DRAFT SYDNEY DEVELOPMENT CONTROL PLAN 2012: APDG SITE BLOCK 4 (REVISED JANUARY 2016)

DRAFT SYDNEY DEVELOPMENT CONTROL PLAN 2012 – APDG SITE BLOCK 4

[1] Section 6.1.4 The APDG site (bounded by Alfred, Pitt, Dalley and George Streets)

Figure 6.9A STREETS, LANES AND THROUGH SITE LINKS - OPTION B

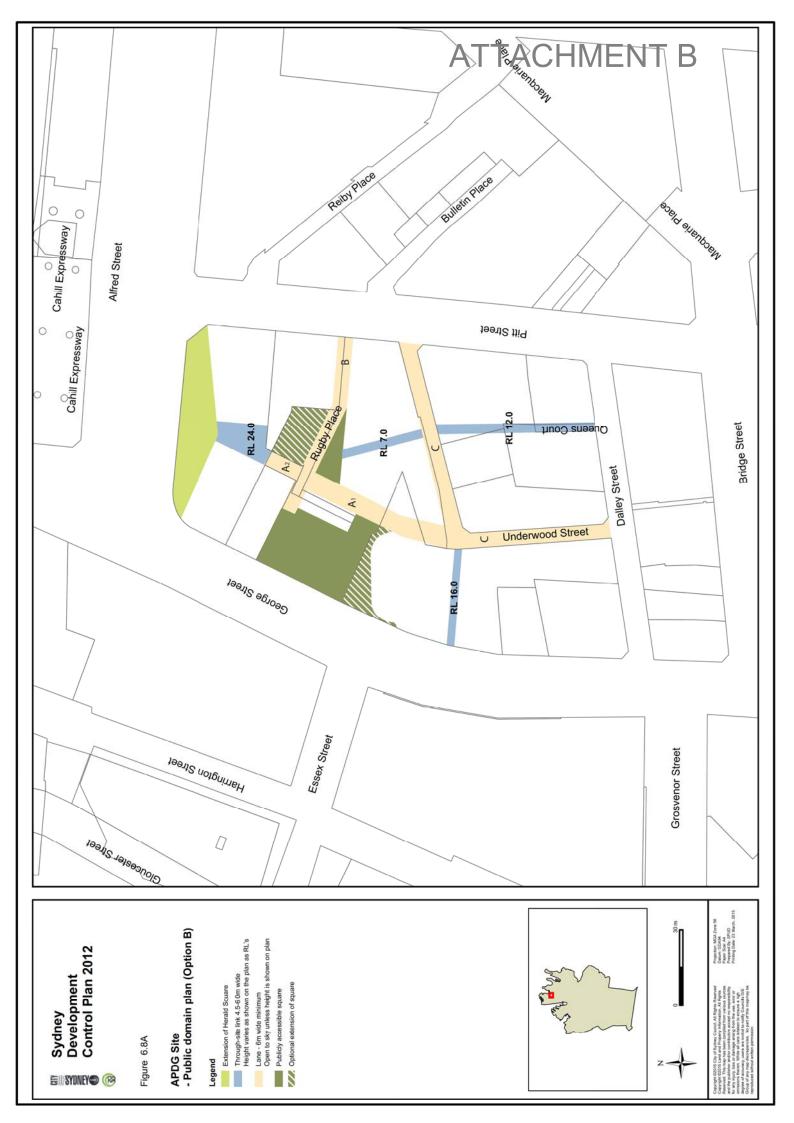
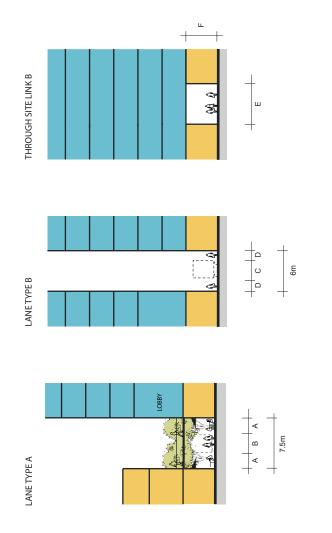
After Figure 6.9, insert Figure 6.9A as shown attached.

Seating & retractable awning or umbrella 2.25m

- B Shared service road 3m. No vehicle access 8am- 6pm Monday to Friday.
 - C Shared service road 3.0m
- D Footpath with flush kerb 1.5m
- E Through site link min. 4m
- F Minimum height 4m on variant

- All seats, tables and umbrellas in the public domain must be removable (consistent with the concept of "naked streets" including minimal signage).
- Laneway awnings must not have fixed elements or vertical screens.
- Other street furniture (eg. planters and temporary bollards) should not be permitted.
- Design of the public domain and lanes should prioritise pedestrian activities and provide an equitable clear path of travel, preferably adjacent to the building line.
- Integrated surface treatments may also be used to provide navigational assistance.
- TGSI and fixed barriers are not preferred.
- Seating areas should be in consistent locations throughout a lane.
